SUBJECT: RESPONSES TO COMMENTS - DRAFT SUPPLEMENTAL PHASE II  
REMEDIAL INVESTIGATION DATA PACKAGE REPORT, INSTALLATION  
RESTORATION PROGRAM SITE 16, FORMER NAVAL CONSTRUCTION  
BATTALION CENTER DAVISVILLE, RI

**Responses to EPA Comments  
Draft Supplemental Phase II  
Remedial investigation Data Package report  
IR Site 16  
NCBC Davisville  
(March 2006)  
(EPA Comments dated 15 May 2006)**

Figure 1. PID Readings vs CVOC Concentrations in Soil

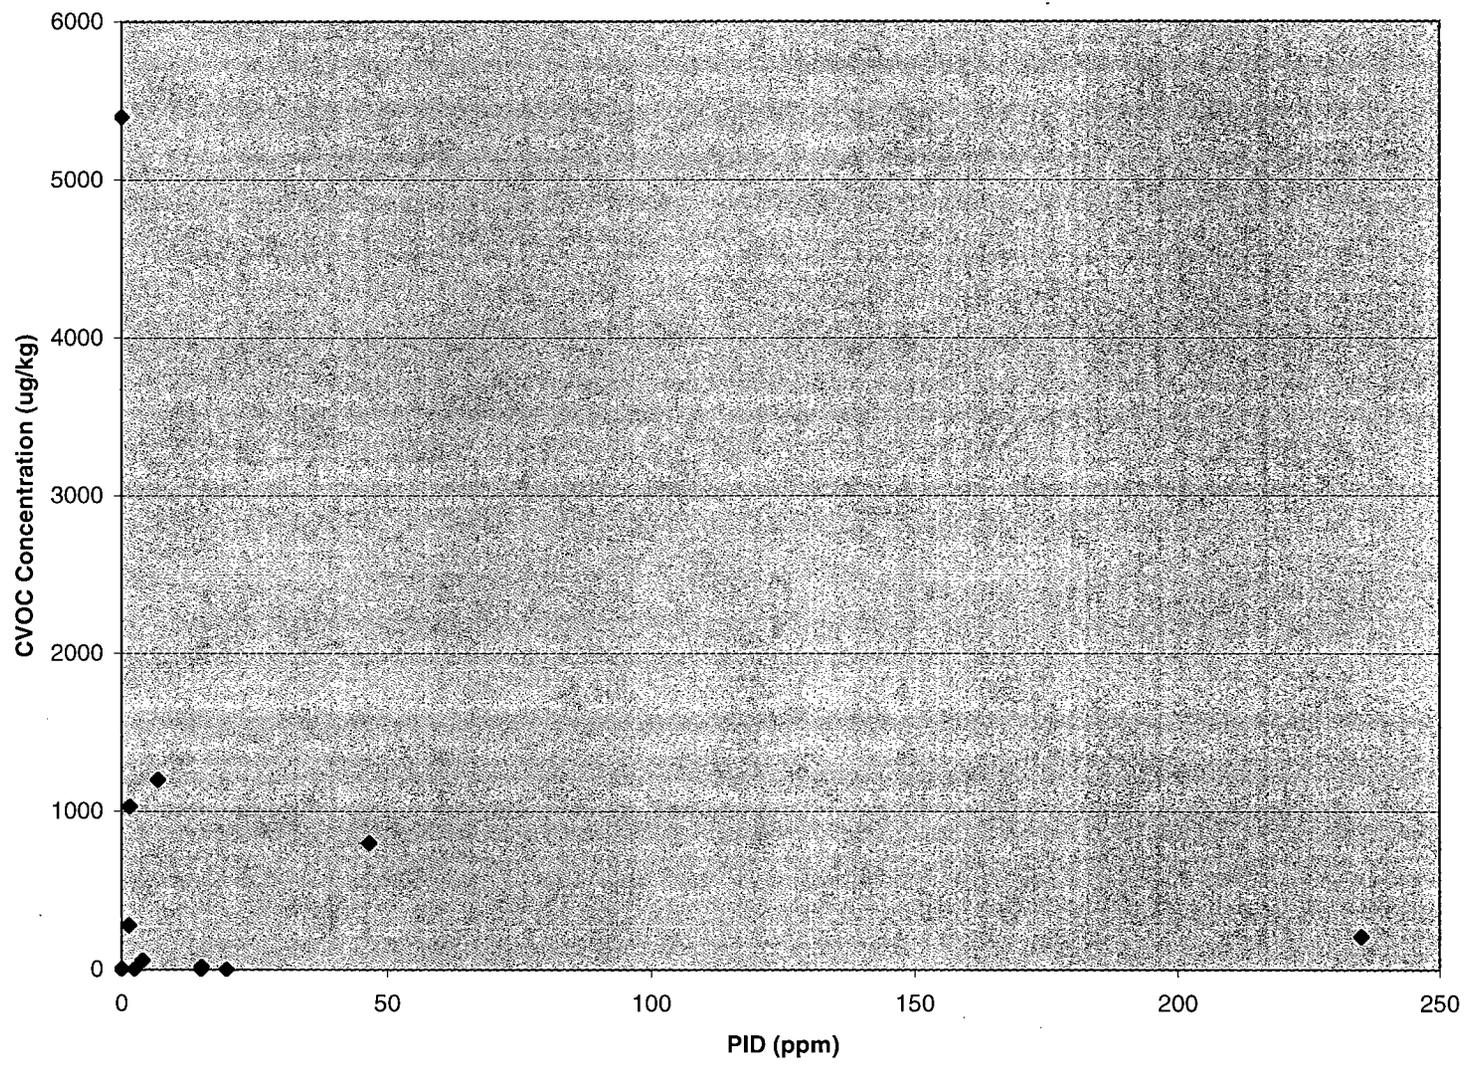
Based on an analysis of Site 16 data, correlation of PID/FID responses to soil and groundwater analytical data is extremely poor. All soil samples with CVOC concentrations and PID readings are listed in Table 1. A graph of PID readings versus CVOC concentrations in soil samples (Figure 1) shows that elevated PID readings can be associated with low CVOC concentrations (e.g., well MW16-04S at 3 to 5 ft bgs) and very low PID readings can be associated with very high CVOC concentrations (e.g., MW16-14D at 57-59 ft bgs, MW16-22D at 59-61 ft bgs, and MW16-15R at 51-53 ft bgs). Groundwater data for MW16-14D was also consistent with soil data in that CVOCs were 4911 ug/L in March 2001 and 3003 ug/L in 2002. The soil boring log for MW16-14D indicates no response from the PID in the 57.5 to 59.5 ft bgs zone. There was a minor PID response in the soil interval just below (12.9 ppm) but a fixed-base lab sample was not collected from that zone.

Figure 2. FID Readings vs CVOC Concentrations in Soil

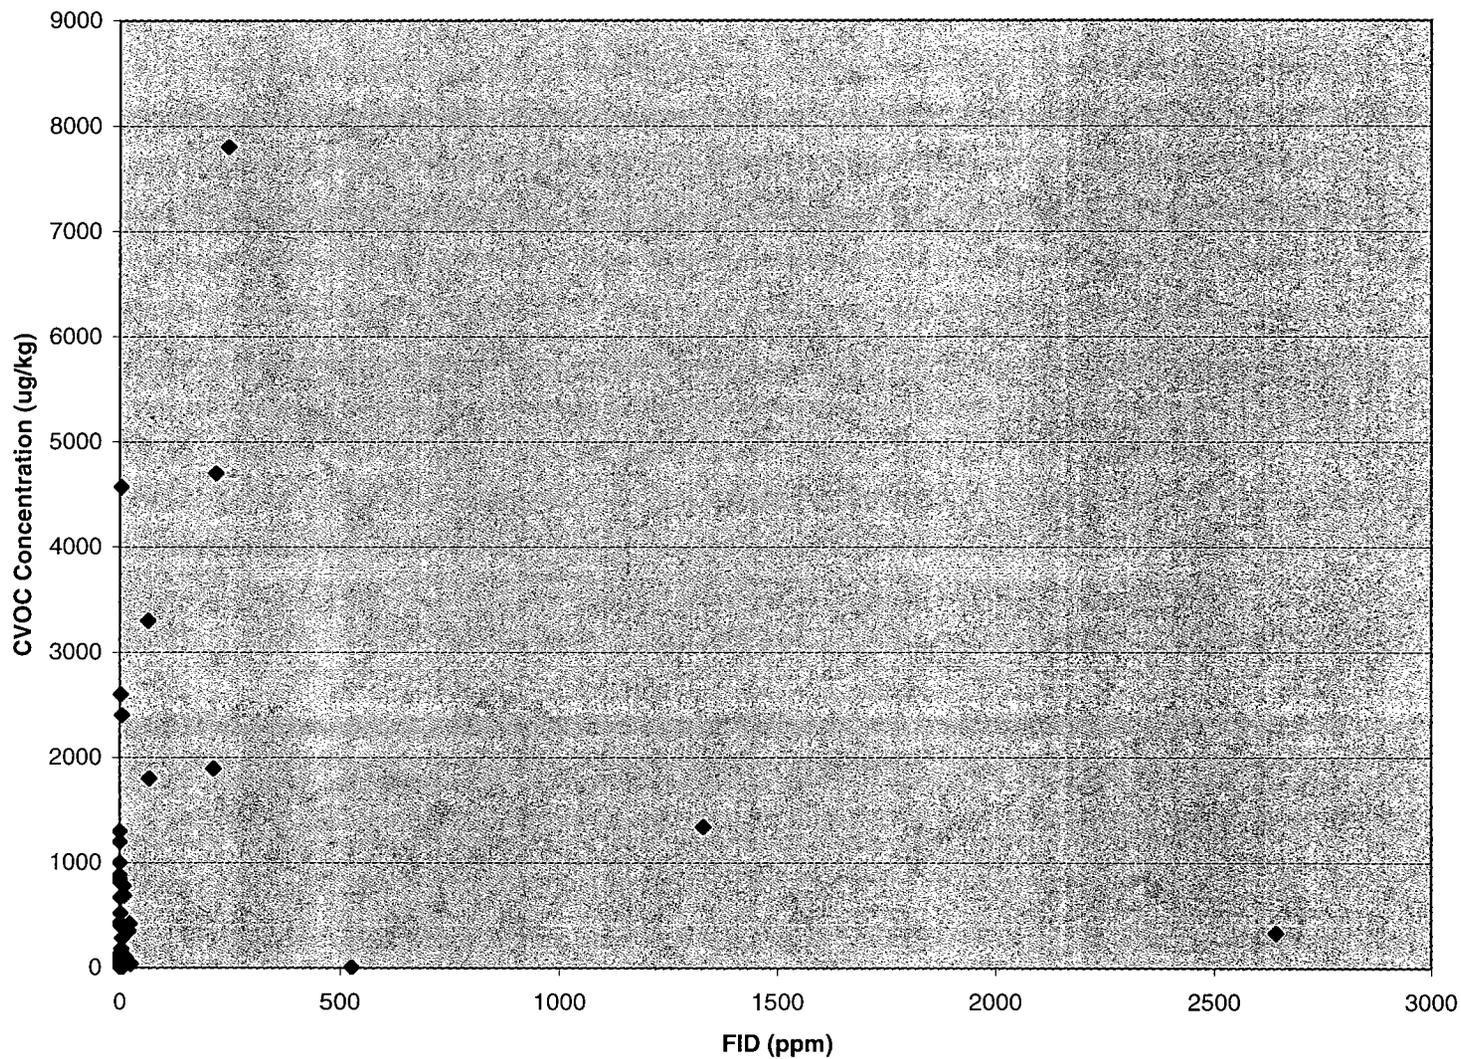
All soil samples with CVOC concentrations and FID readings are listed in Table 1. A graph of FID readings vs CVOC concentrations in soil samples (Figure 2) shows that elevated FID readings can be associated with low CVOC concentrations (e.g., SB16-45 at 14-16 ft bgs and SB16-46 at 12-14 ft bgs) and low FID readings can be associated with very high CVOC concentrations (e.g., INJ16-01D at 48-50 ft bgs, SB16-32/MW16-32D at 56-58 ft bgs, MW16-62D at 55-57 ft bgs, and MW16-63D at 48-50 ft bgs).

**GEOLOGIC CROSS-SECTION A-A'**  
 DAVISVILLE ROAD / FFTA AREA  
 RP SITE 18  
 FORMER DAVISVILLE NAVAL  
 CONSTRUCTION BATTALION CENTER  
 NORTH KINGSTON, RHODE ISLAND

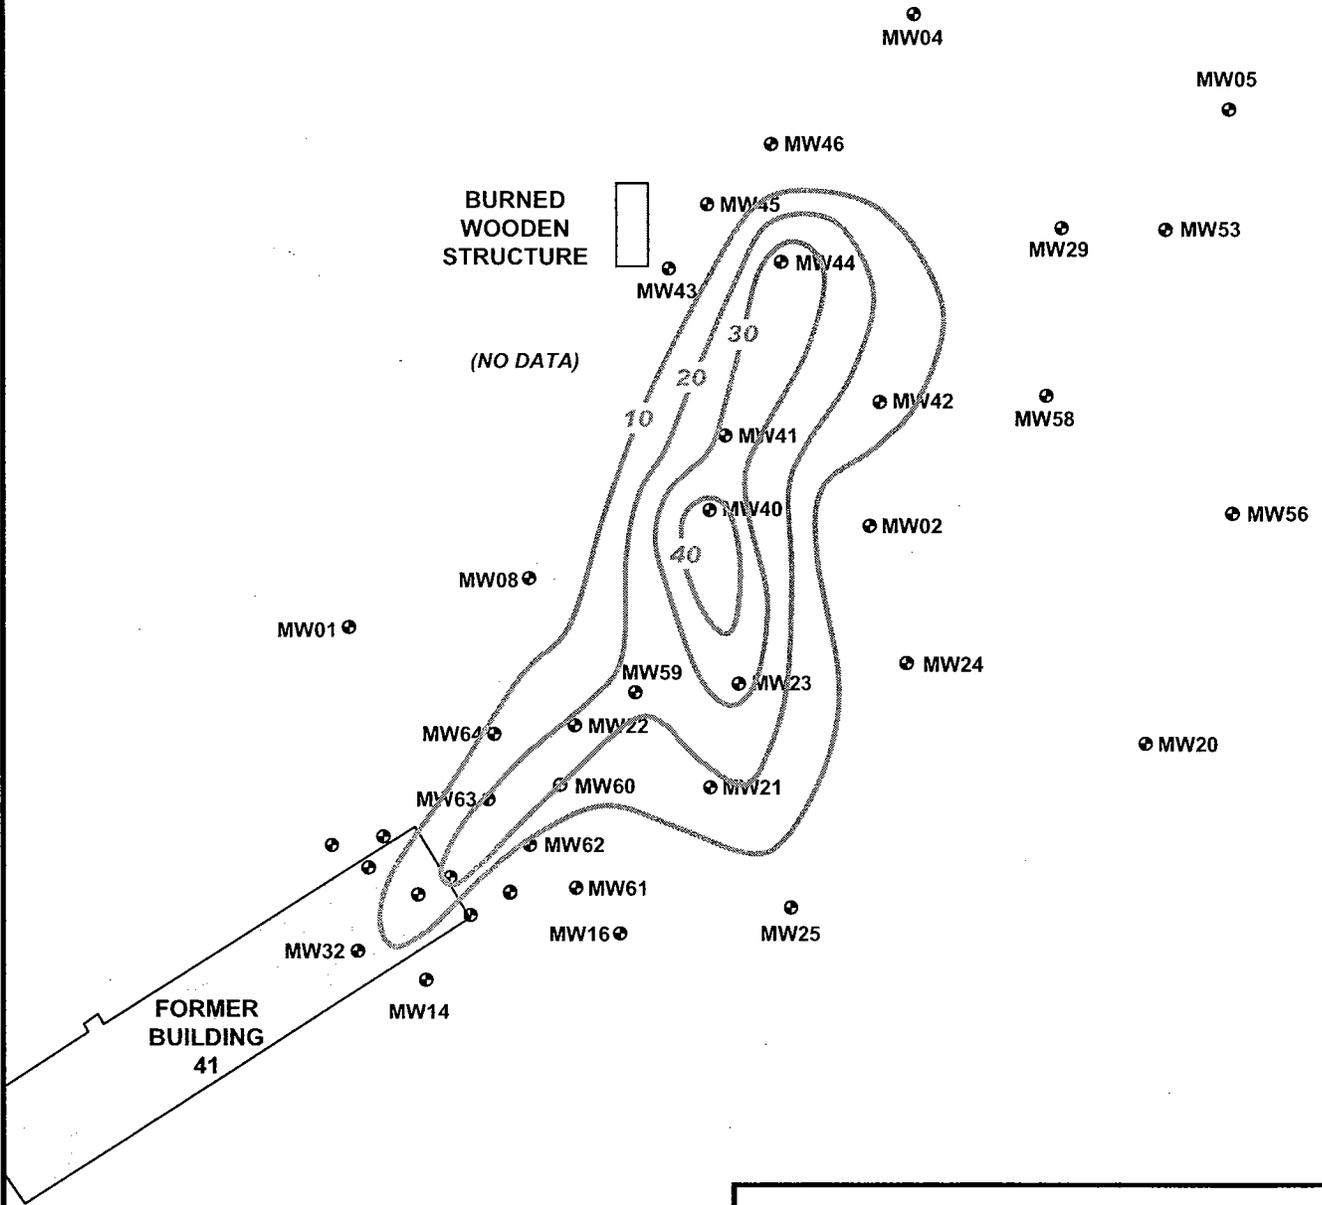
A portion of cross section A-A", Figure 3-2A in the source report, also depicts a portion of the potential contaminant migration pathway as presented on EPA Figure 5. As depicted in this cross section, there are no laterally extensive silt layers. In EPA Figure 5, the silt layer was assumed to be laterally continuous between MW16-02 and MW16-22. As detailed on this cross section, this assumption is not correct. Not only are the lithologies of the silt layers different, but they are separated by sands and sandy silts.

Perhaps the most noteworthy feature of the cross sections prepared by the Navy is the lack of the silt layer in the FFTA. Of further note is that the laterally extensive peat layer is generally lower in elevation in the FFTA than just south of the FFTA (near MW16-41). As depicted in Figure 2, prepared by the EPA, the confining silt layer is located just above this peat layer. Even if the silt layer was present in the FFTA, which it is not, based upon the cross sections provided, contamination would have to migrate both vertically upward and against the direction of groundwater flow as it moved southward from the FFTA to the former Building 41.

<b>NCBC SITE 16 DAVISVILLE, RHODE ISLAND</b>		
<b>INTERMEDIATE CVOC ISOPLETHS</b>		
	CDW CONSULTANTS, INC. 40 SPEEN STREET SUITE 301 FRAMINGHAM, MA 01701 TEL. (508) 875-2657	DRAWN: JEL CHECKED: CGL DATE: 05/07/06 SCALE: AS SHOWN
	<b>FIGURE 3</b>

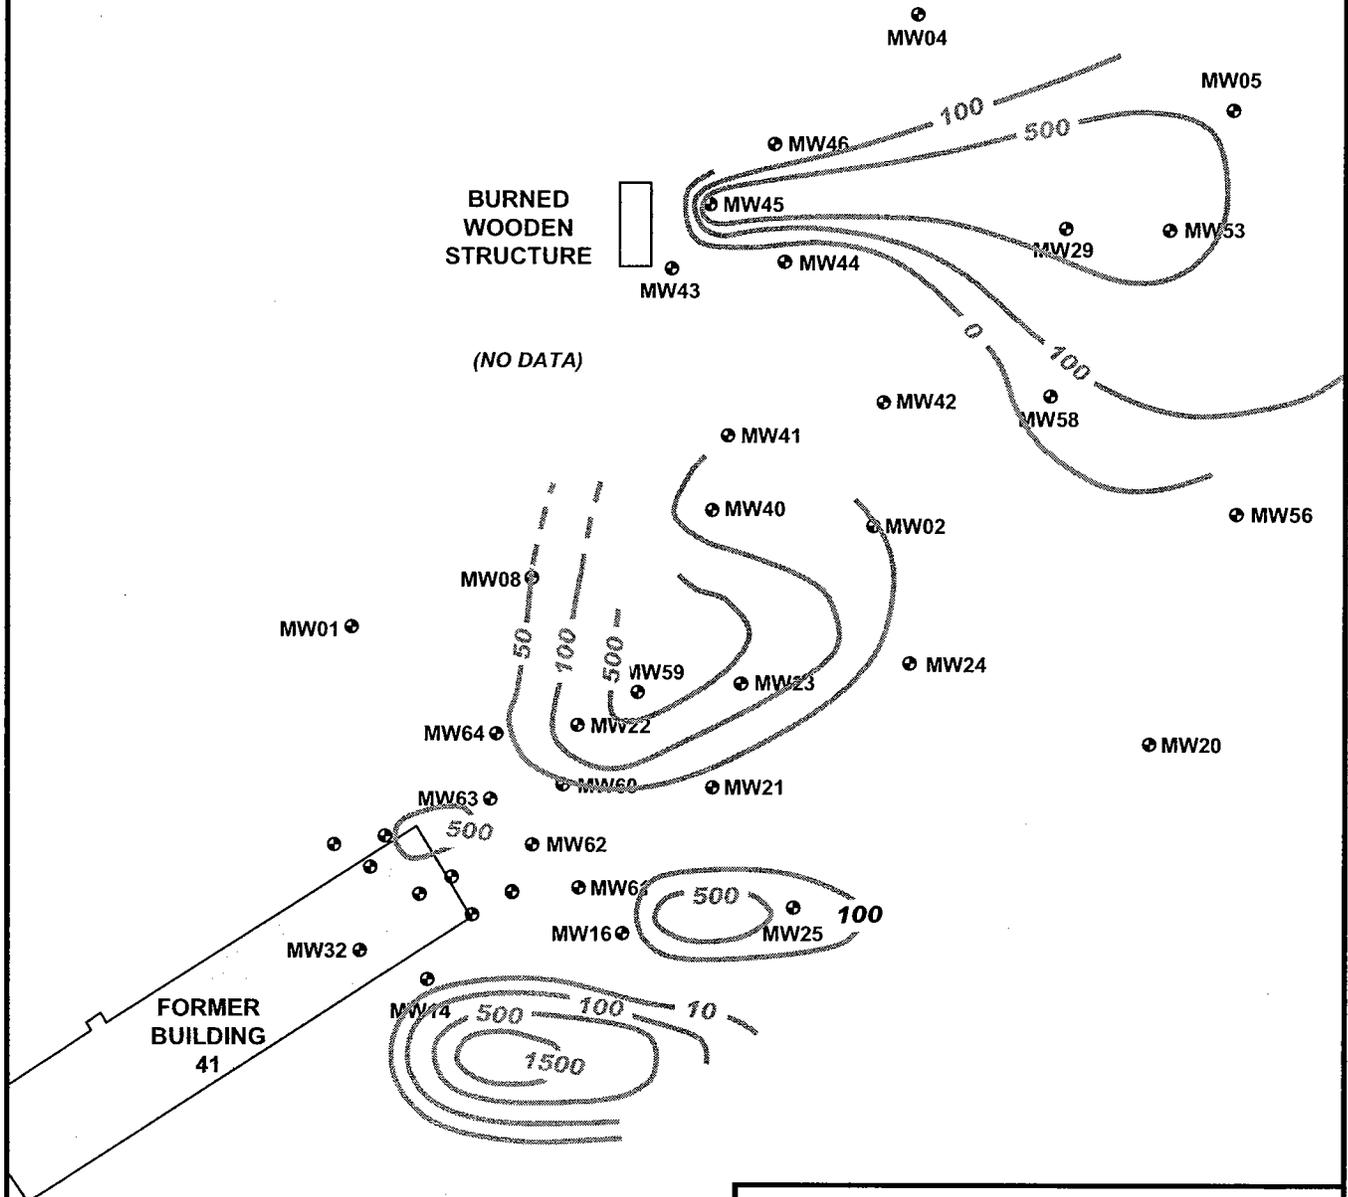
34. **Specific Comment:** *Page 4-18, 3<sup>rd</sup> Paragraph:* A somewhat different interpretation of the distribution of CVOC in the intermediate overburden was developed by EPA Contractor (GF-CDW) as shown on Figure 3. This interpretation indicates that there are likely multiple source areas that move in one or more directions to contribute CVOC contamination to groundwater. While there is a pocket of elevated CVOC southeast of the former Building 41 footprint, there are at least two additional source areas. The first appears to be related to the area that appears to be contributing CVOC contamination to the shallow groundwater south of Davisville Road originating north of Davisville Road.

<b>NCBC SITE 16 DAVISVILLE, RHODE ISLAND</b>		
<b>TOP OF SILT</b>		
	CDW CONSULTANTS, INC. 40 SPEEN STREET SUITE 301 FRAMINGHAM, MA 01701 TEL. (508) 875-2657	<b>DRAWN: JEL</b> <b>CHECKED: CGL</b> <b>DATE: 05/07/06</b> <b>SCALE: AS SHOWN</b>
	<b>FIGURE 5</b>

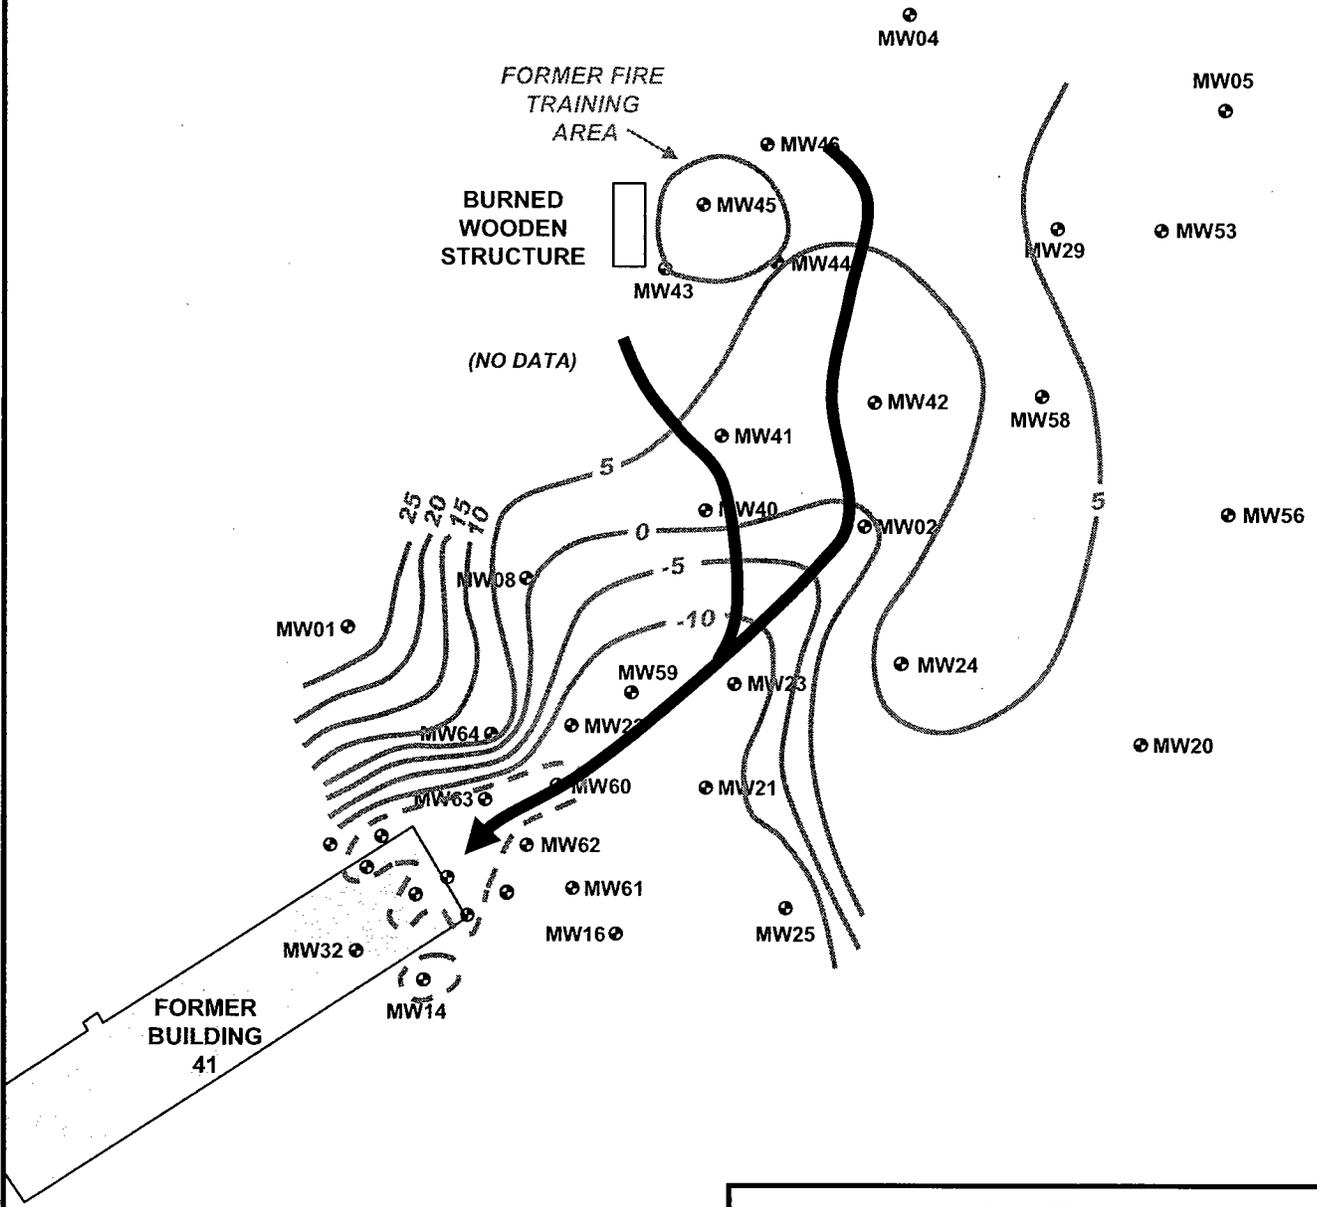
Inspection and analysis of the boring logs presented on EPA Figure 5 shows that for much of the area presented in this figure, a continuous, dipping silt layer does not exist. In fact, based on the boring logs, there is no evidence of silt as defined by the EPA at the elevations assumed at three of the four monitoring wells at the FFTA (MW16-43, 45 and 46 have no silt layer at the elevations presented) and at two of the down-dip monitoring wells (MW16-23 and MW16-59). In addition to the monitoring wells in the FFTA and near former Building 41 where no silt layer as defined by EPA is observed, there is also no silt layer at MW16-41. Furthermore, the first encountered silt layer at MW16-43 is observed at approximately 33 feet below ground surface (-16 feet MSL). If this first silt layer from MW16-43 had been used in the construction of Figure 5 by EPA as well as the consideration of the absence of silt at the other locations cited above, the resulting top of silt map produced would be significantly different than the map presented. As presented, the top of silt map depicted in Figure 5 is inaccurate and therefore not useful.

A further indication for the origin of CVOC at a location other than the eastern end of the former Building 41 area is the distribution of the top of silt elevations for Site 16. A generalized depiction of the top of silt was prepared by EPA Contractor (GF-CDW) and is shown on Figure 5. The top of silt was interpreted from soil boring logs with silt being defined as a definite silt unit as opposed to sandy silt or silty sand. While the figure is generalized and interpretation of the soil boring logs may result in some minor variations of specific top of silt elevations, there clearly appears to be a trough of silt that dips from the area north of Davisville Road toward the former Building 41 footprint. Of special note is the absence of a silt layer entirely in the area of the eastern end of the former Building 41 area. As depicted by the arrows, the likely pathway for DNAPL released in the area north of Davisville Road would be counter to the general groundwater flow direction down the dipping silt layer to the area where the silt disappears. However, this is a characteristic physical feature of DNAPL migration.

**Navy Response:** Comment already addressed. Again, there is no evidence of a continuous silt layer as described by EPA. Please provide evidence in the boring logs for all data points used to construct Figure 5. If no silt is present at the silt layer horizon, gaps must be incorporated in the figure to show where no silt occurs.
